# MEMORANDUM

**FILE NO.:** CSP2013 0008

**PROPOSAL:** Pavement rehabilitation on Riverside Dr. from Egan Dr. to James Blvd. Sidewalks will be added to both sides from Egan to Mall Rd. Drainage improvements to include installation of curb and gutter. Constructed on behalf of CBJ utilizing FHWA NHS Funds.

RE: Federal Project No. STP-0967(7) - State Project No. 69527  
JNU: Riverside Drive Rehabilitation and Widening, Egan Dr. to James Blvd.

## SIGNING & STRIPING PLAN

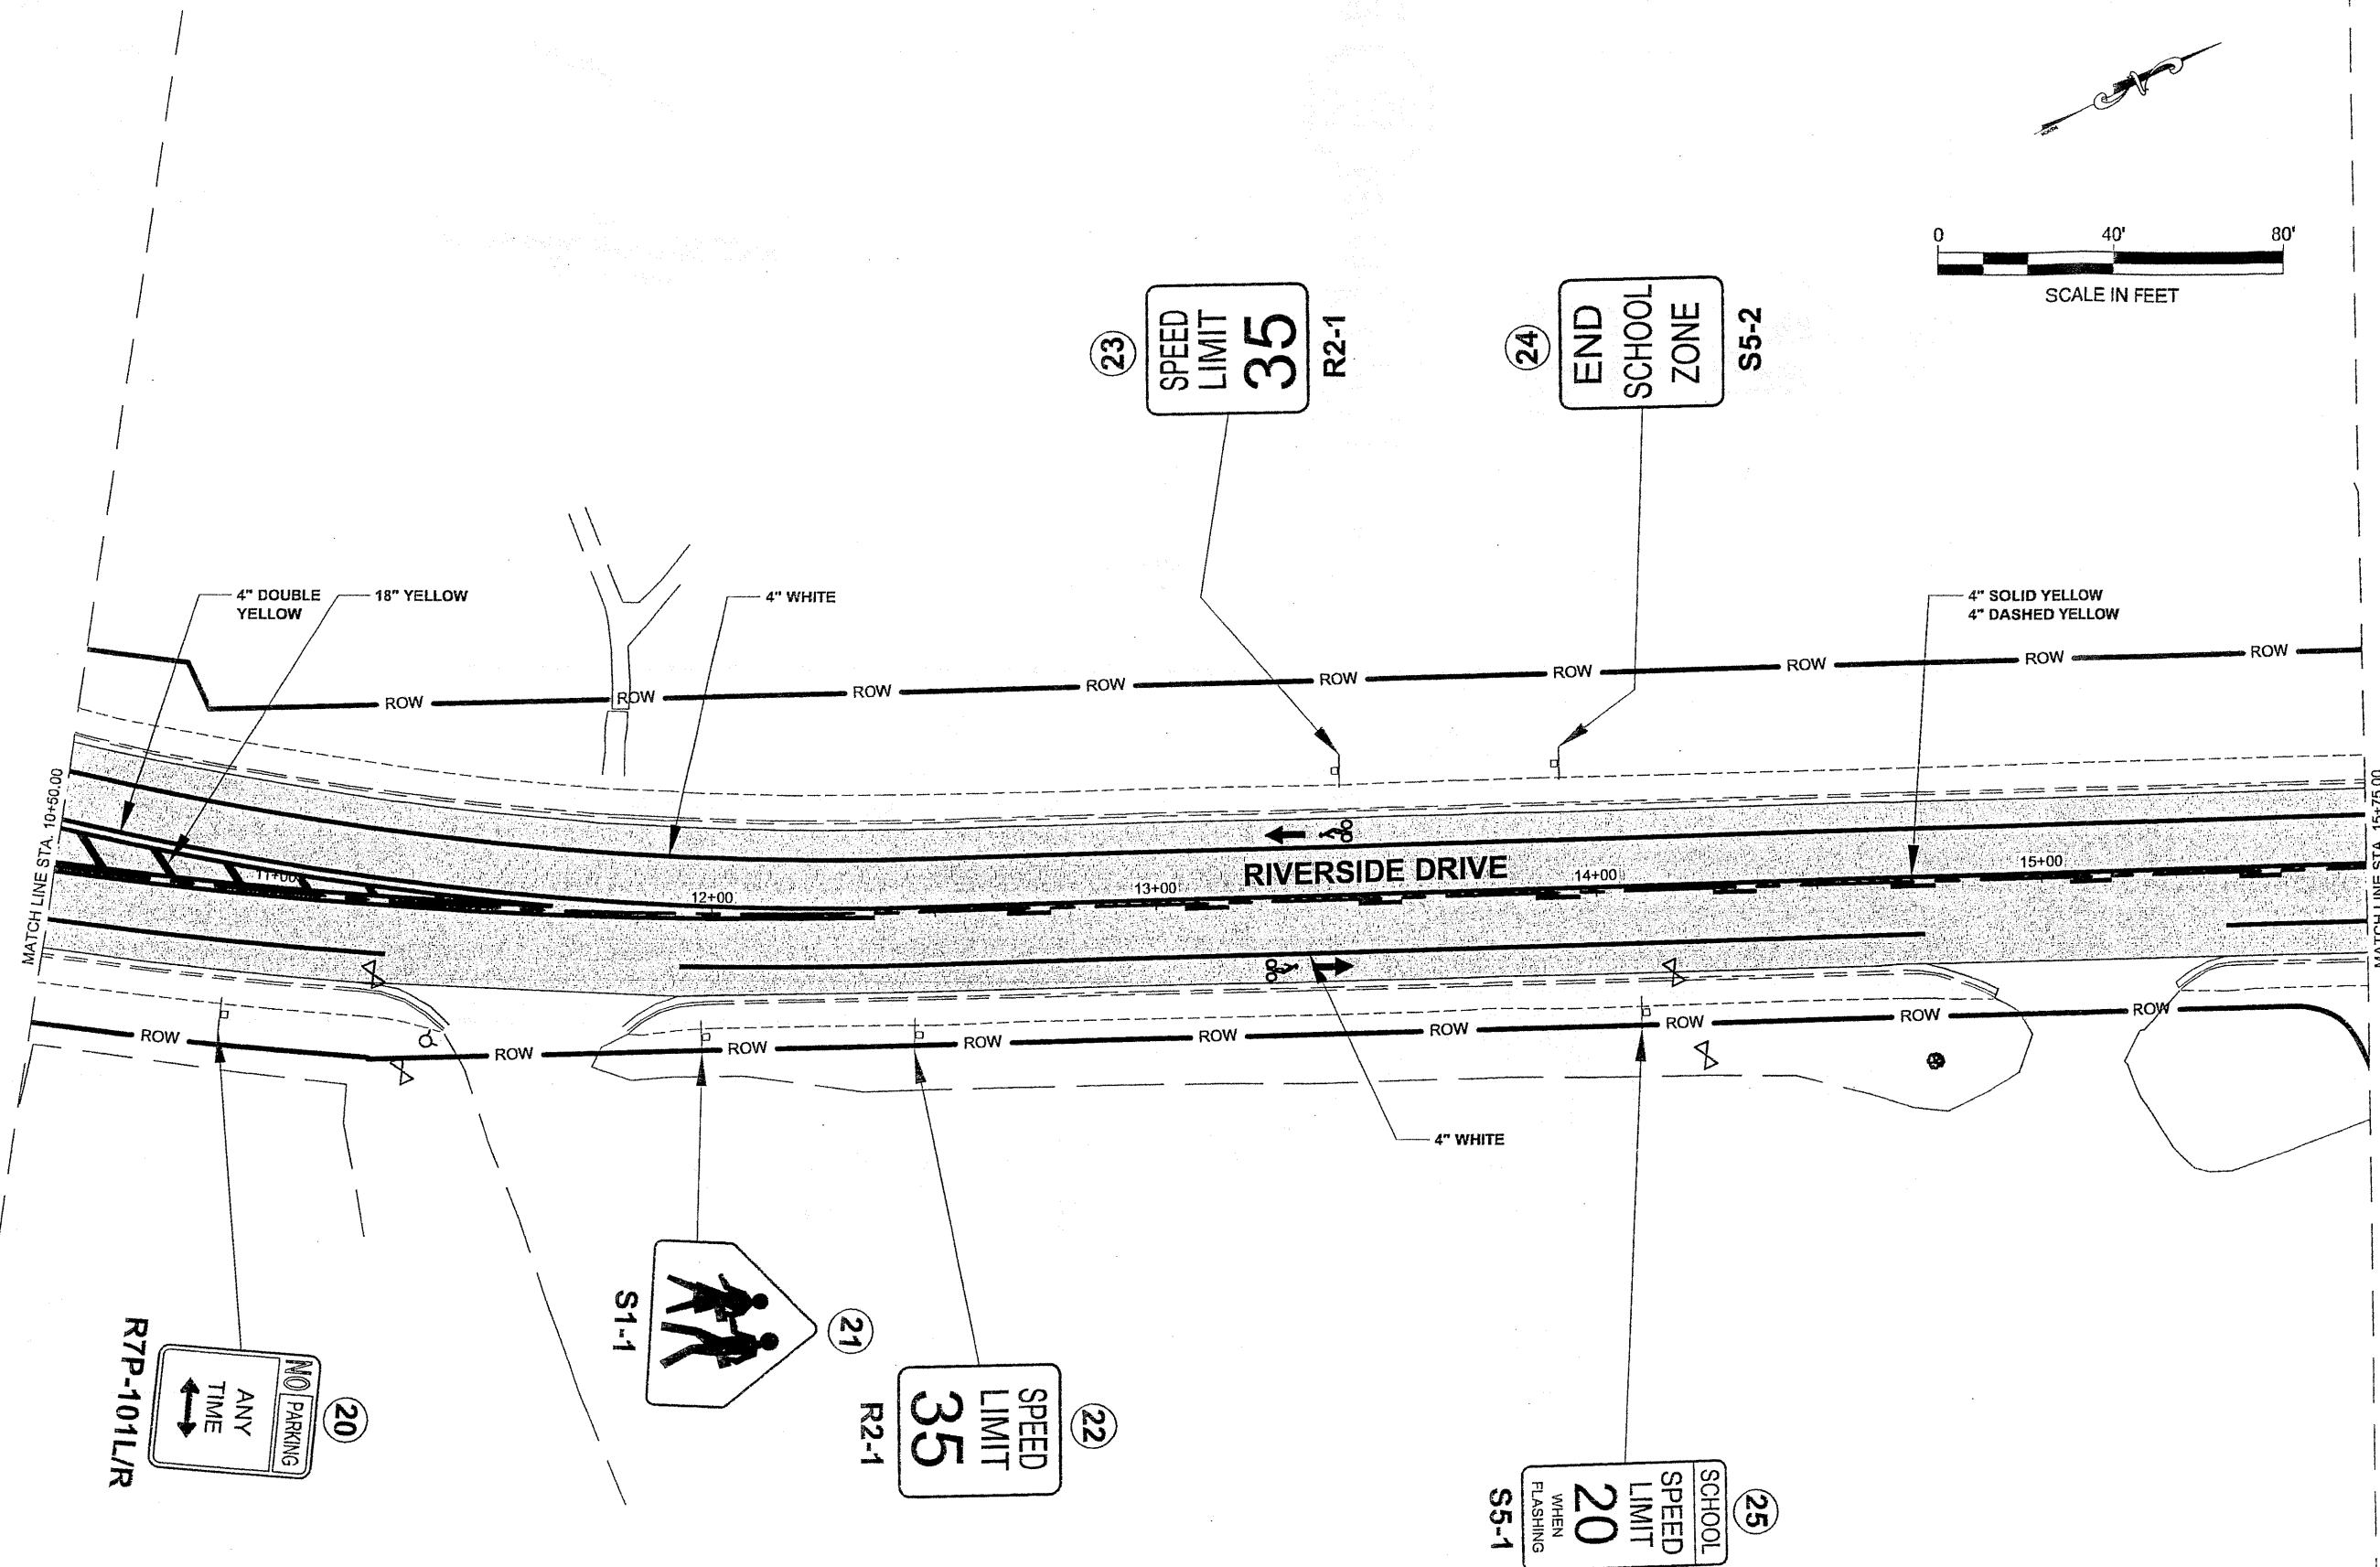
Bicycle lanes currently exist and are clearly marked with appropriate signage along Riverside Drive north of the project area and along both sides of Riverside Drive between Mendenhall Mall Road and James Boulevard; the proposed project would not modify the bicycle lane width, however, re-striping over the years has resulted in the unintentional and sub-standard width of the painted bicycle lane just north of Vintage Boulevard (west side of Riverside Drive); this painted pinch will be eliminated and the bicycle lane re-striped to meet the minimum five-foot standard width requirement for bicycle lanes set by AASHTO (American Association of State Highway and Transportation Officials)(Attachment B, sheets R2 and R3). Dedicated bicycle route connections to the separated paths running along the north side of Egan Drive would not be provided, but the shoulder of Riverside Drive can be used by bicycles, and bicycles are legally able to ride in traffic on Riverside Drive. Access to the separated paths on the north side of Egan from the shoulders would be through the newly constructed pedestrian ramps at the intersection of Riverside Drive and Egan Drive. As the land on either side of this portion of the corridor is in commercial use, bicycles will be prohibited from riding on the new sidewalks between Egan Drive and Vintage Boulevard/Mendenhall Mall Road (CBJ 72.02.400(f), CBJ 72.02.487(b), and 13 AAC 02.400(g)). The plans submitted for the intersection of Riverside Drive/Mendenhall Mall Road/Vintage Boulevard show pedestrian refuge islands located where they obstruct the through-bicycle lane; in this plan, bicyclists traversing this intersection would either need to ride with traffic or dismount and use crosswalks to navigate the intersection. This intersection treatment is not consistent with the American Association of State Highway and Transportation Officials *Guide for the Development of Bicycle Facilities* (2012), which calls for continuing bicycle lanes through intersections with the right-turn lane on the right of the through-bicycle lane (Attachment F). This inconsistency was brought up with the DOT&PF Project Manager, Keith Karpstein, who agreed that the proposed intersection configuration was not appropriate considering the bicycle lanes to the north and south of the intersection. Mr. Karpstein stated (phone message June 4, 2013) that the configuration shown on the striping plans reflected

existing conditions, and that the configuration of the intersection and its striping plan would be amended to provide for through-bicycle lanes. Since plans showing this modification to the project have not been drafted or submitted for review, staff recommends that a condition be placed on the finding of concurrence requiring that the intersection be revised according to the designs shown in Attachment F.

1. The pedestrian-activated crosswalk warning system required as Condition 5 of USE2003-00055 as amended by USE2009-00051 must be installed as part of this project.
2. Bicycle route and way finding signs meeting the requirements of the *Manual on Uniform Traffic Control Devices* (MUTCD), as amended and adopted by DOT&PF, shall be installed as specified in the MUTCD throughout the project area. Final sign placement shall be subject to Community Development Department staff review and approval,

3. The intersection of Riverside Drive, Vintage Boulevard, and Mendenhall Mall Road will be reconfigured and striped so as to provide for through-bicycle lanes on Riverside Drive, consistent with the American Association of State Highway and Transportation Officials *Guide for the Development of Bicycle Facilities* (2012), and with particularity Figure 4-20.

Figure 4-20. Examples of Bike Lanes Approaching Right-Turn-Only Lanes (With and Without Parking)

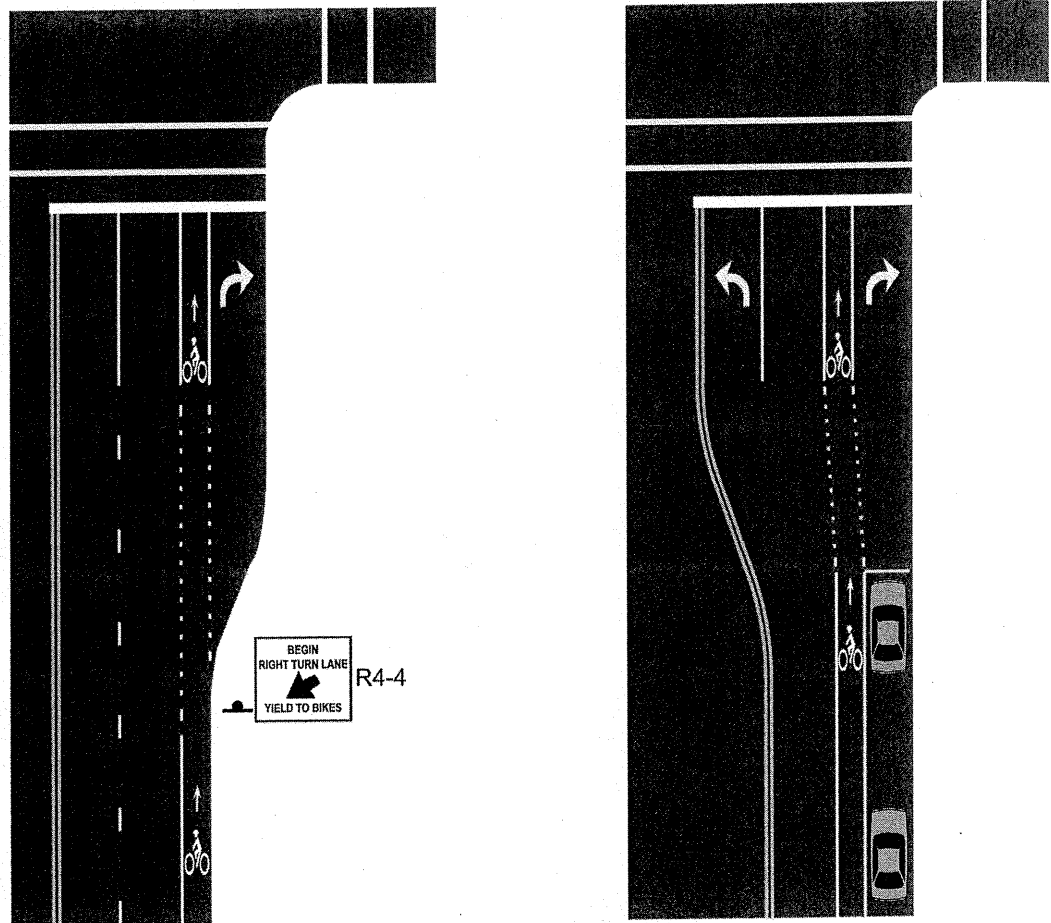
The proposed project is largely in conformance with Adopted Plans. Because it is not shown on the project drawings submitted for review, staff recommends that the pedestrian-activated crosswalk warning system required as Condition 5 of USE2003-00055 as amended by USE2009-00051 be made a condition of a finding of conformance. Furthermore, with no bicycle route or way finding signage proposed, the project is not in conformance with the Non-Motorized Transportation Plan Policy 6 and Implementing Action 6D; accordingly, staff recommends a condition that signage consistent with Implementing Action 6D be included in the project, subject to Community Development Department staff review and approval. Finally, staff recommends that a condition be placed on the concurrence finding requiring the intersection of Riverside Drive, Vintage Boulevard, and Mendenhall Mall Road be reconfigured to accommodate through-bicycle lanes consistent with the American Association of State Highway and Transportation Officials *Guide for the Development of Bicycle Facilities* (2012), especially Figure 4-20 in Attachment F.
